### CAO23-011 CRITICAL AREA REVIEW 2

<b>Project No.:</b>	CAO23-011
<b>Description:</b>	A request for a Critical Area Review 2 for the demolition of an existing single-family residence and construction of a new approx. 4,000 square foot single-family residence on a property located within mapped geologically hazardous areas.
<b>Applicant / Owner:</b>	Jeffrey Almeter / Dorothy Strand
<b>Site Address:</b>	6950 SE Maker St, Mercer Island, WA 98040; Identified by King County Assessor tax parcel number 935090-0620.
<b>Zoning District:</b>	Single Family Residential (R-8.4)
<b>Staff Contact:</b>	Molly McGuire, Planner <a href="mailto:molly.mcguire@mercerisland.gov">molly.mcguire@mercerisland.gov</a> / (206) 275-7712
<b>Exhibits:</b>	<ol style="list-style-type: none"><li>1. Development Application, received by the City of Mercer Island on July 3, 2023</li><li>2. Revised Development Plan Set, August 29, 2023</li><li>3. Project Narrative, received July 4, 2023</li><li>4. Hazard Report, generated August 9, 2023</li><li>5. Geotechnical Engineering Study and Critical Areas Study prepared by Geotech Consultants, Inc., dated March 21, 2022 and received July 3, 2023</li><li>6. Review of Revised Pl

PERMANENT SHORING PLAN

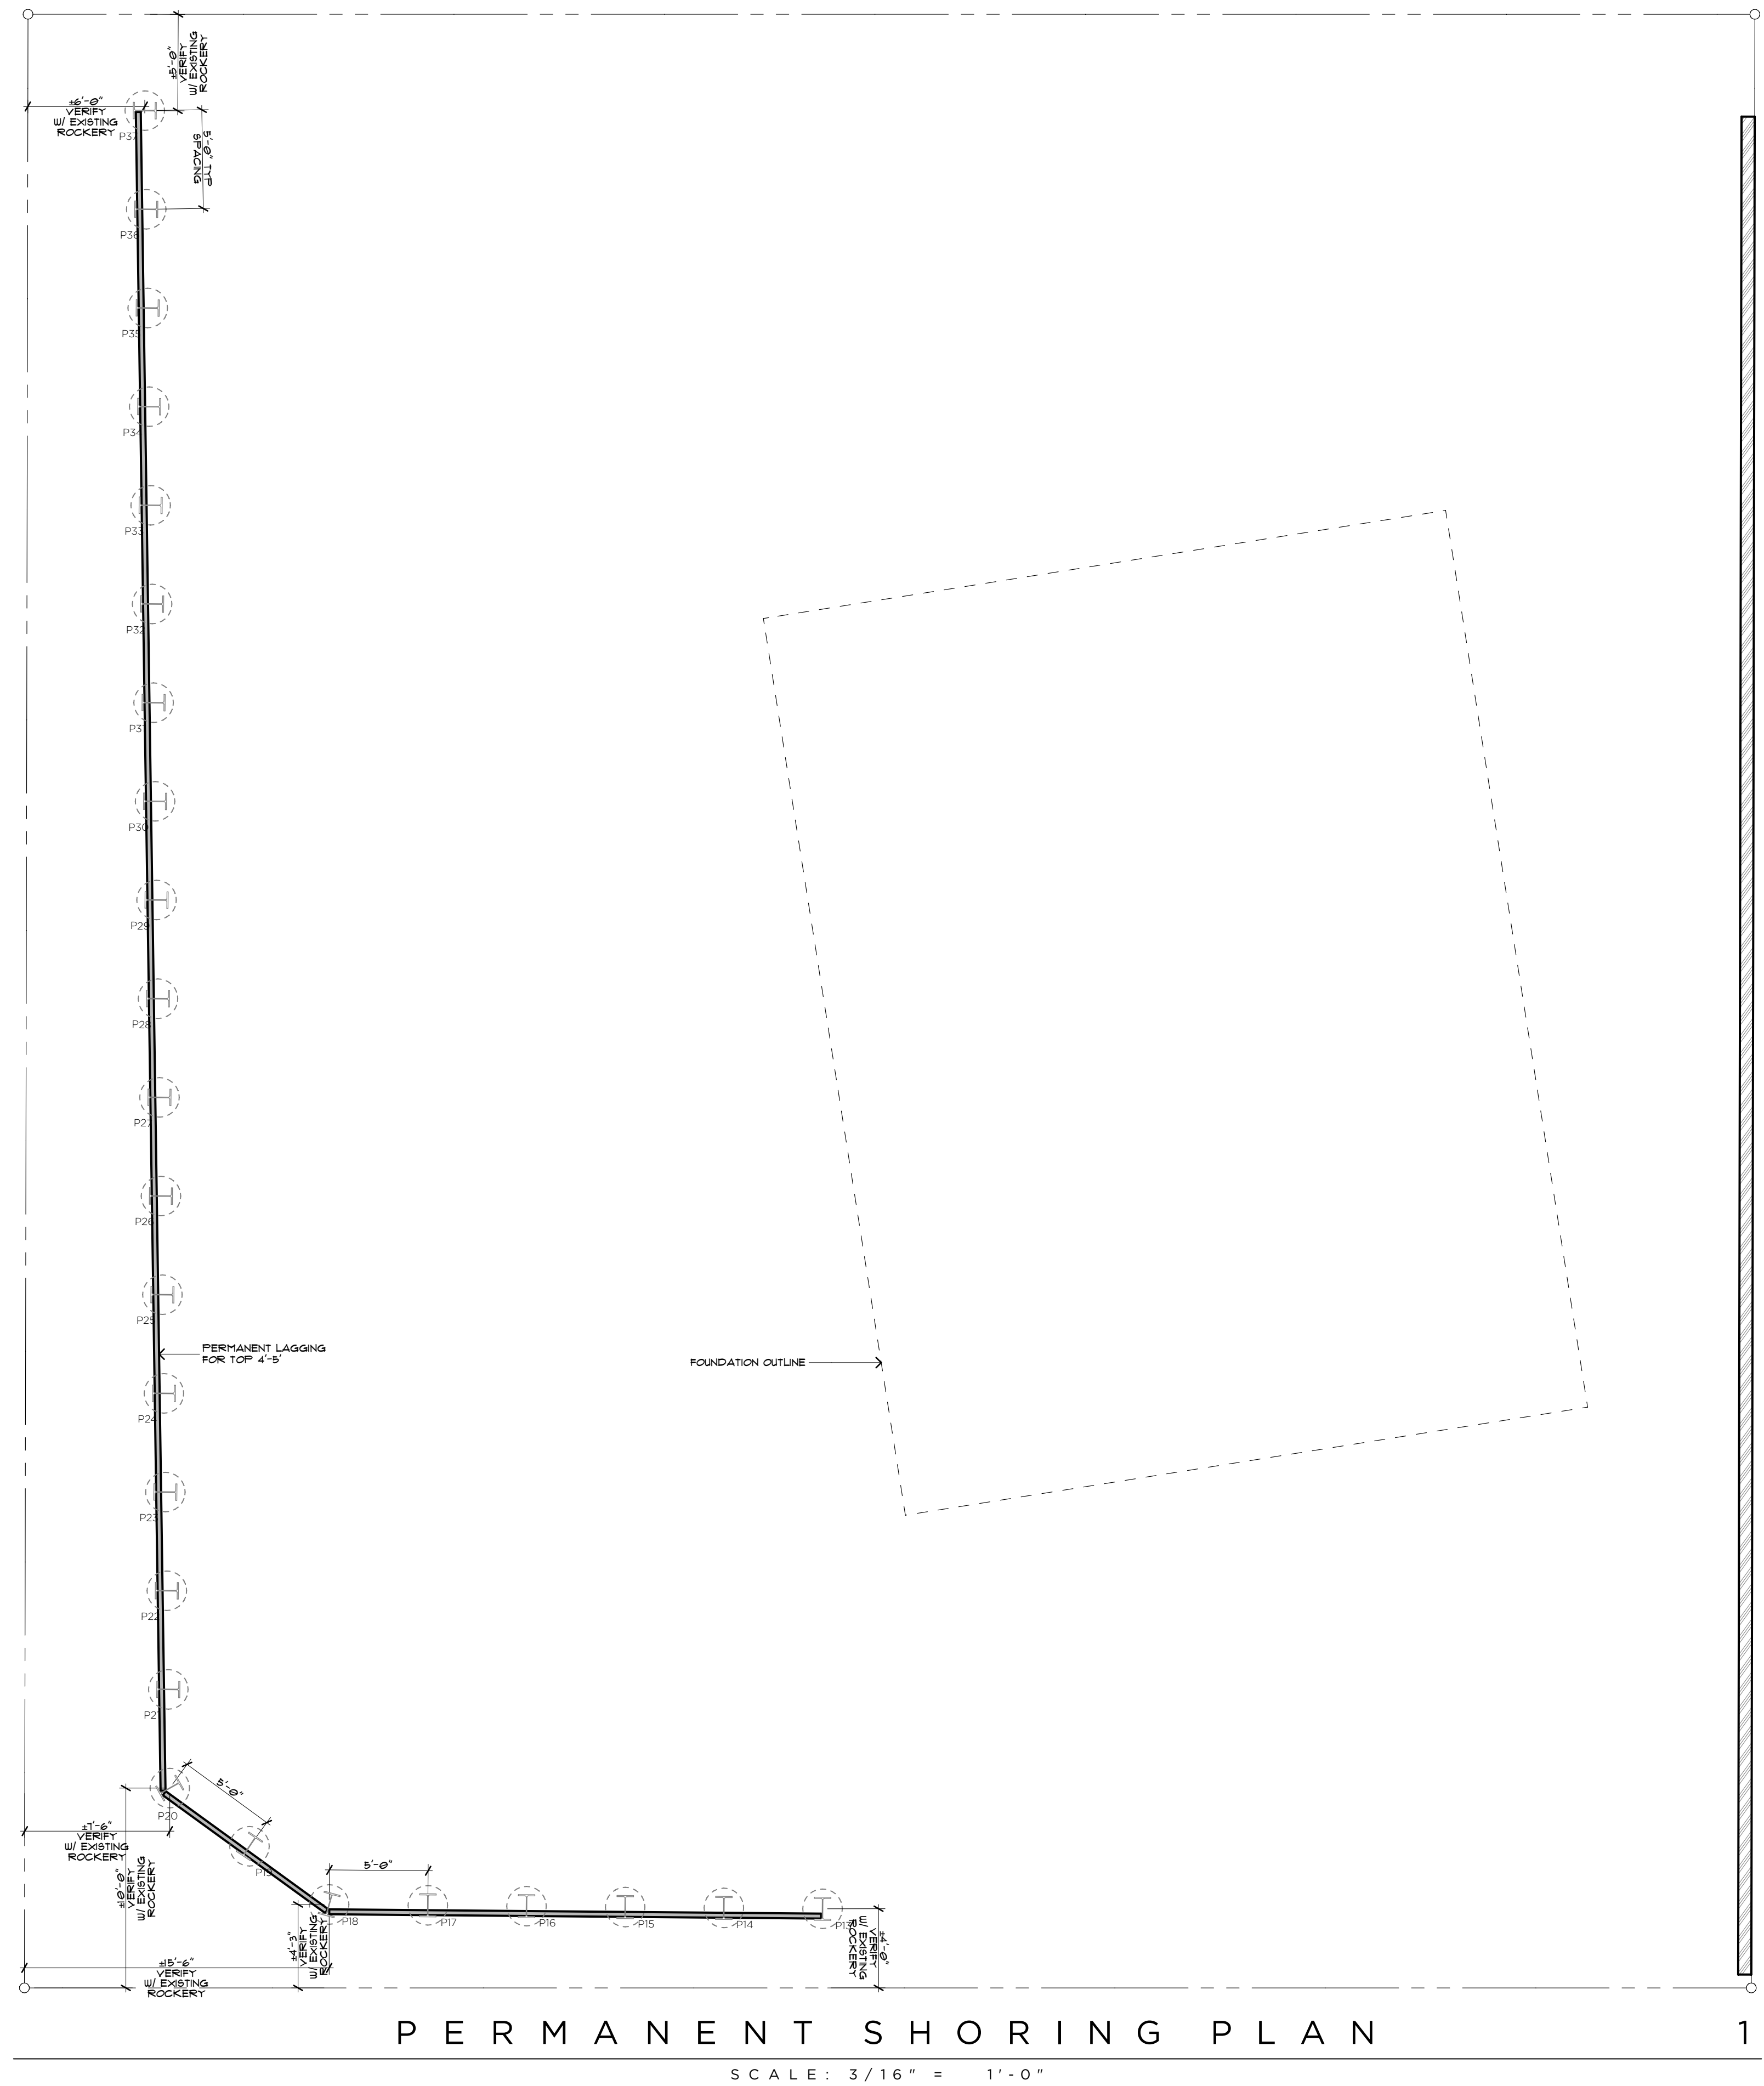
- 19.02.050(E)(1)(a)(i) - The proposed combined rockery + retaining wall for the fill slope in the western Required Side Yard and Required Rear Yard exceed the maximum allowed height of 72 inches. The proposed retaining wall in these yards is ~120" (Piles 23 through 37 in the table from SUB3, sheet SH3 below).
- 19.020.050(E)(1)(a)(ii) - The proposed combined rockery + retaining wall for the fill slope in the Required Front Yard exceeds its maximum allowed height of 42 inches. The proposed retaining wall in these yards is ~120" (Piles 13 through 22 in the table from SUB3, sheet SH3 below).

JOB NO. 22038  
SHEET  
**C-2**

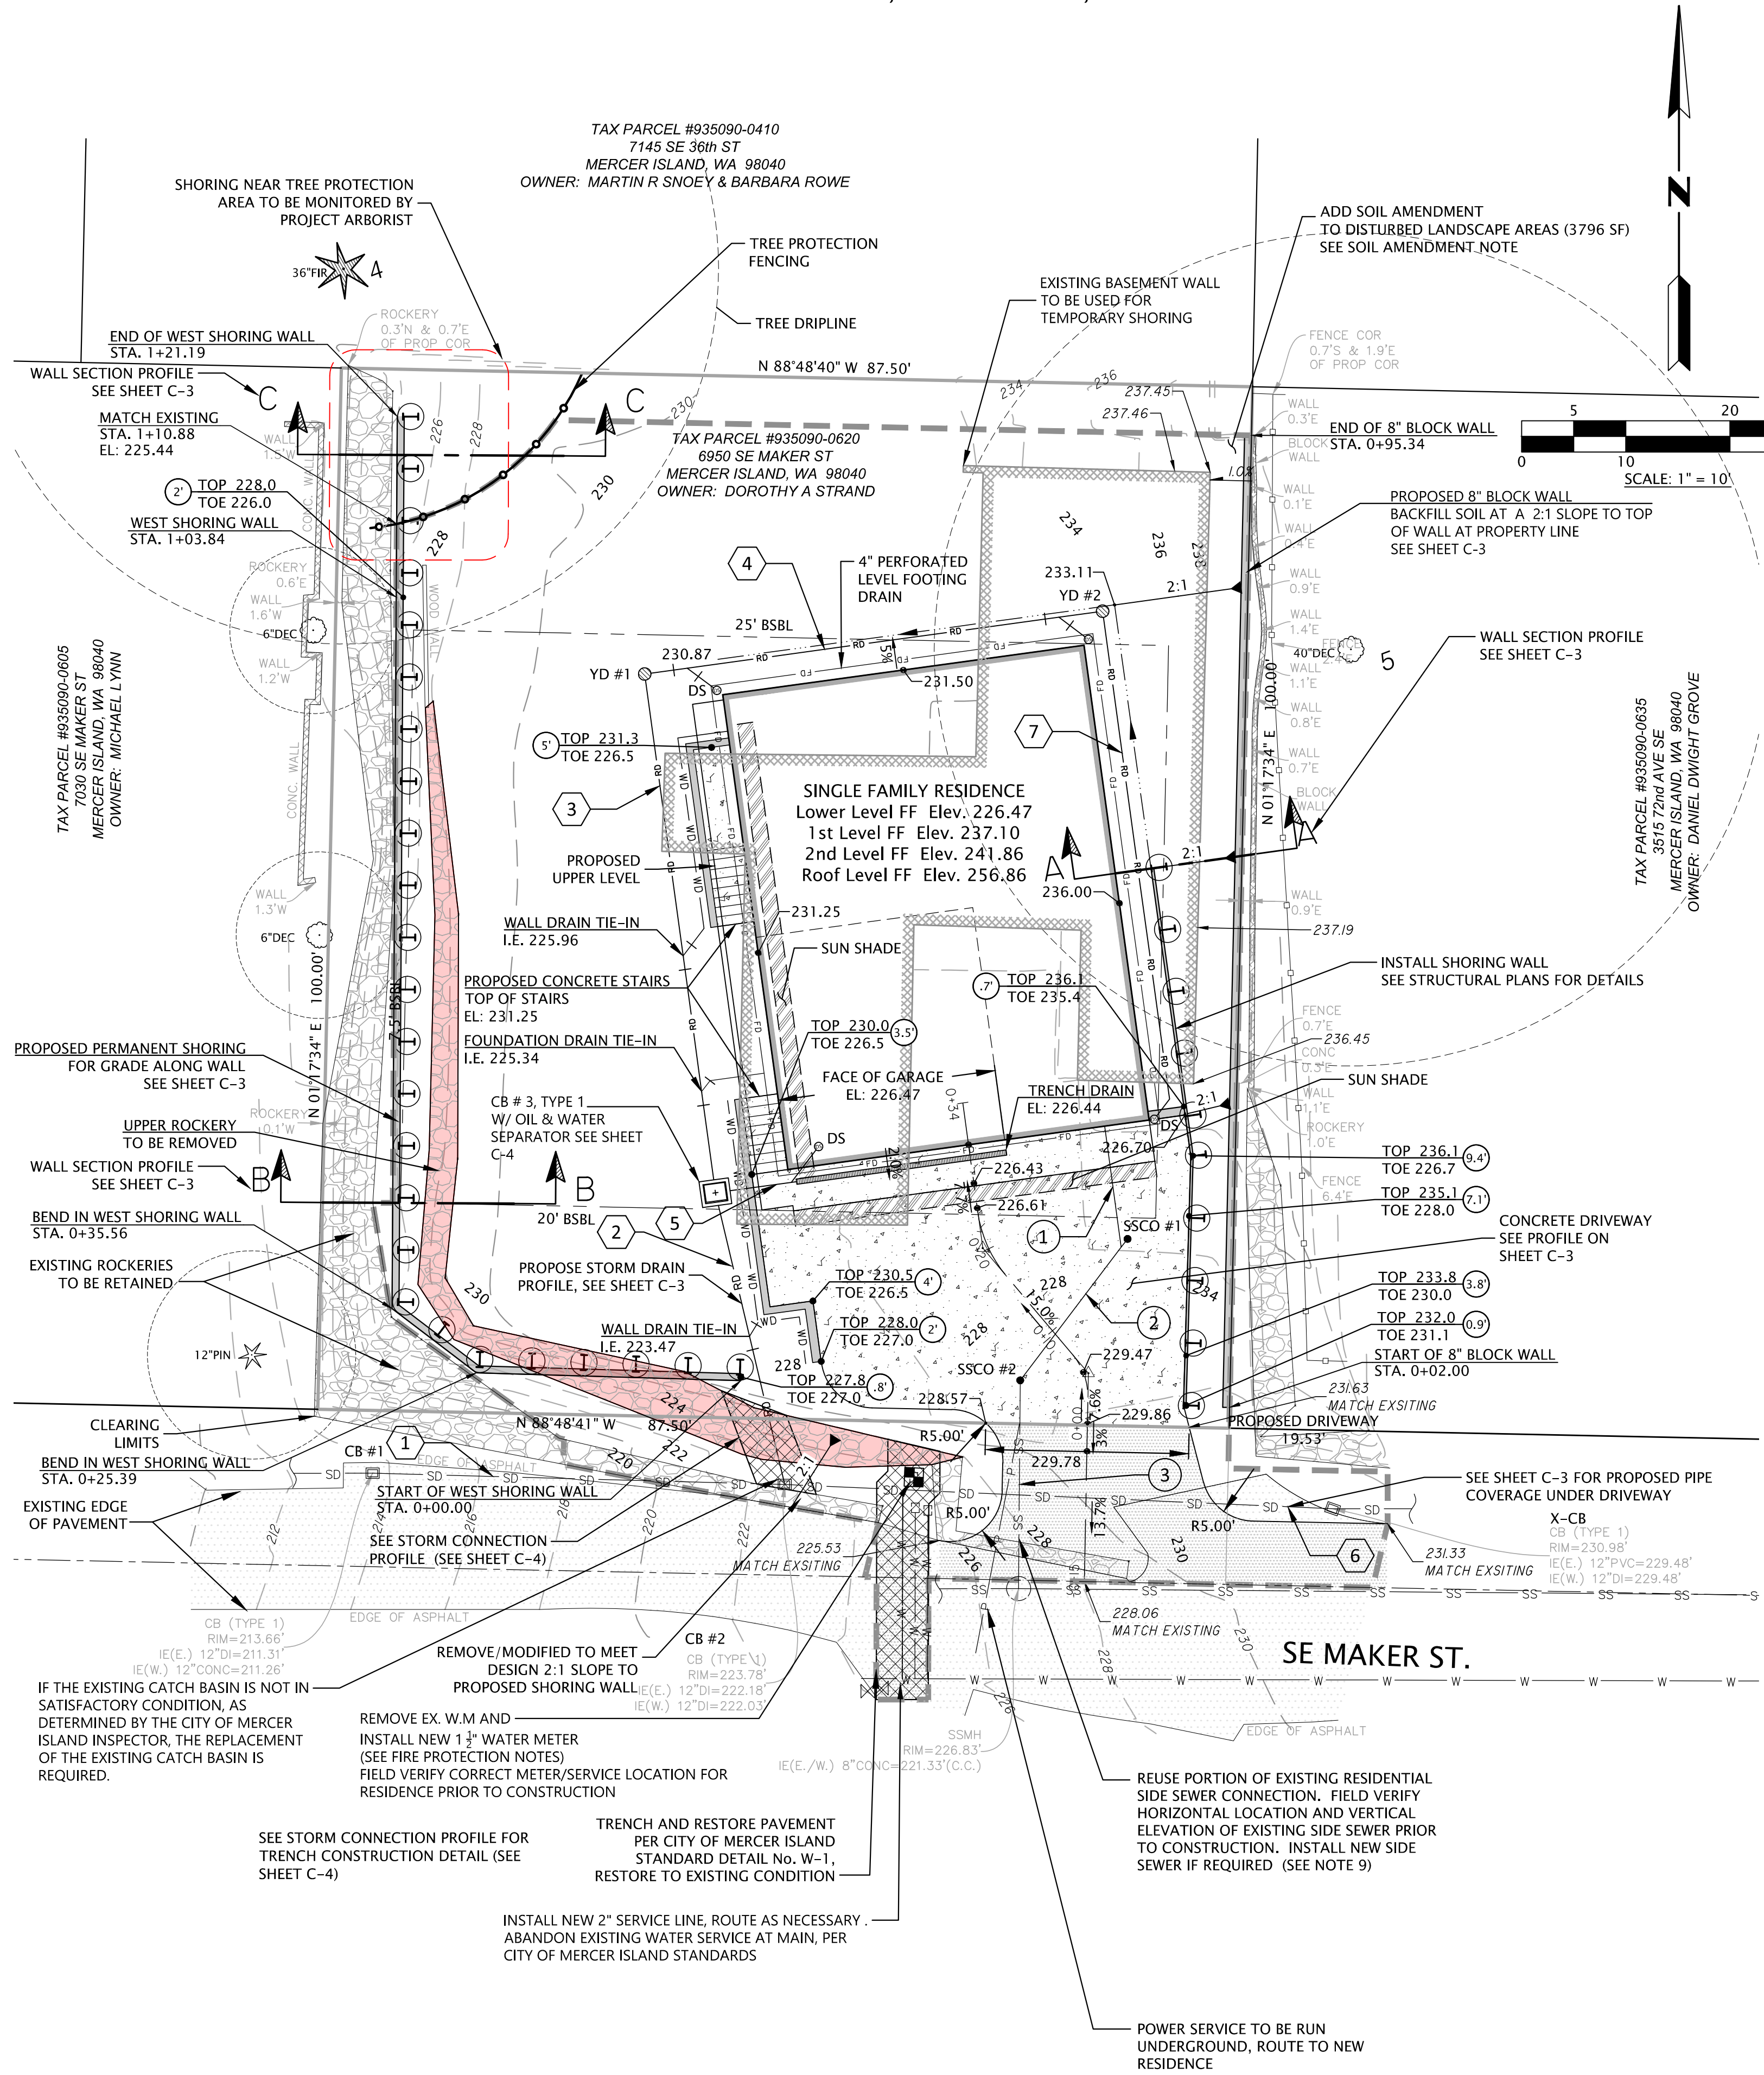
The Site Plan and sections on SH1, as well as sheets C-2 and C-3, properly illustrate the fill berm and modular block wall to be constructed as protection against a potential failure of the eastern neighbor's modular block wall.

Figure 1. Excerpt from page C-2 of the submitted plan set. The base of the fir is roughly at the 214 grade level. Fir tree rarely if ever have roots deeper than 3' below grade. It is highly unlikely that this tree has any significant root density in the area east (right) of the existing rock wall.

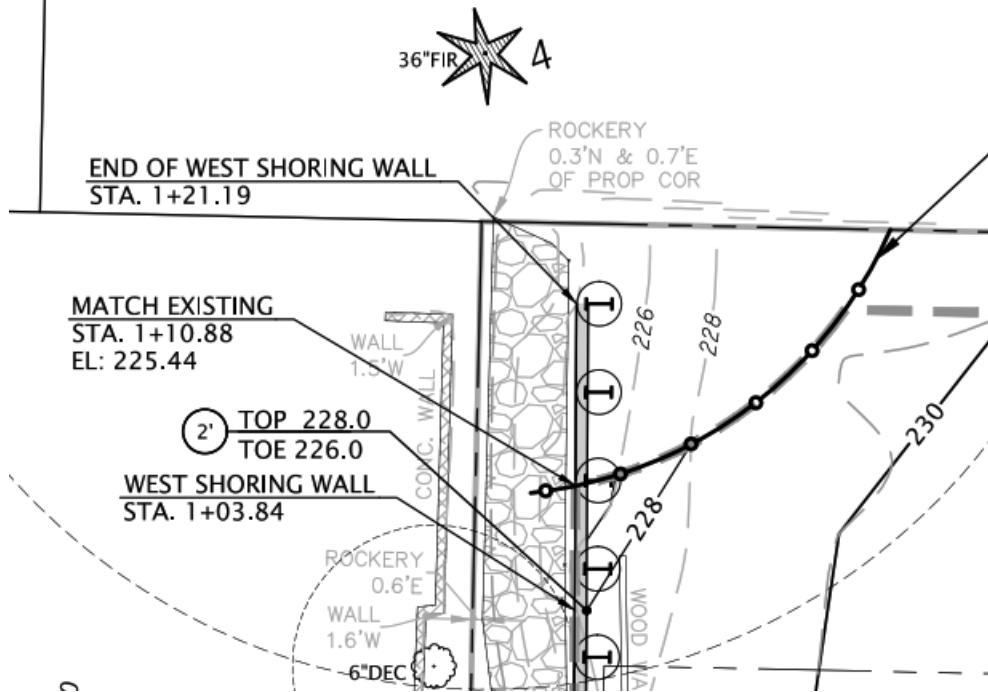
Based on the plan set drawing shown in Figure 1 the north end of the new wall will terminate 15' out from the base of the tree. This means there is no chance that the work will damage the Structural Root Plate of the tree.

EXHIBIT 3  
 STABILIZATION WALL  
 INSIDE CRITICAL  
 ROOT ZONE (CRZ)

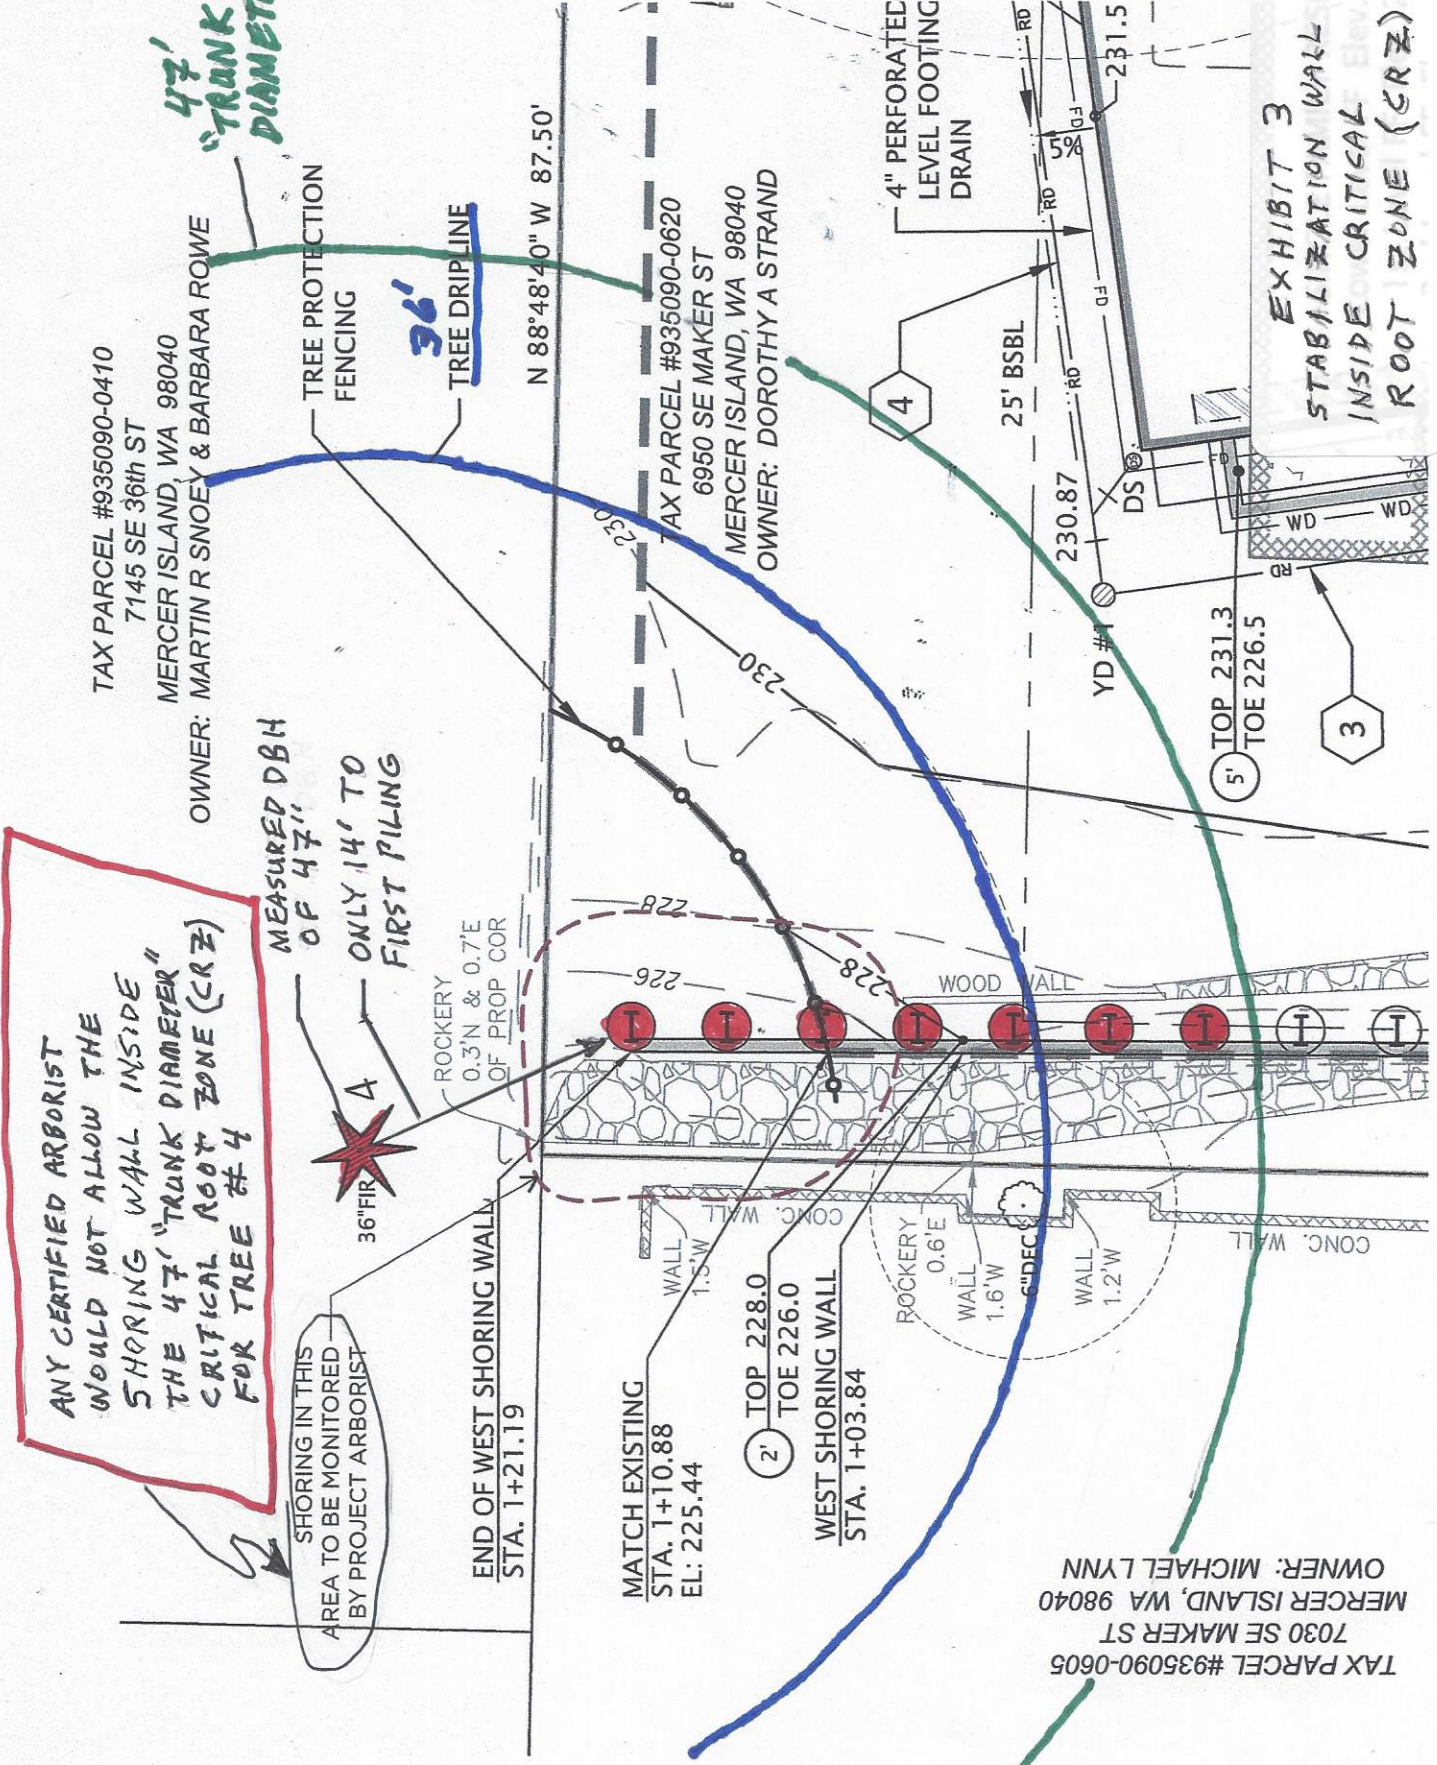
Exhibit 5 shows best estimates of the massive damage to the roots in the CRZ of Tree # 4. Exhibit 5 also concludes that at a minimum, the stabilization wall would damage and remove about 1/3 of the roots in the CRZ semi-circle facing south towards the stabilization wall.
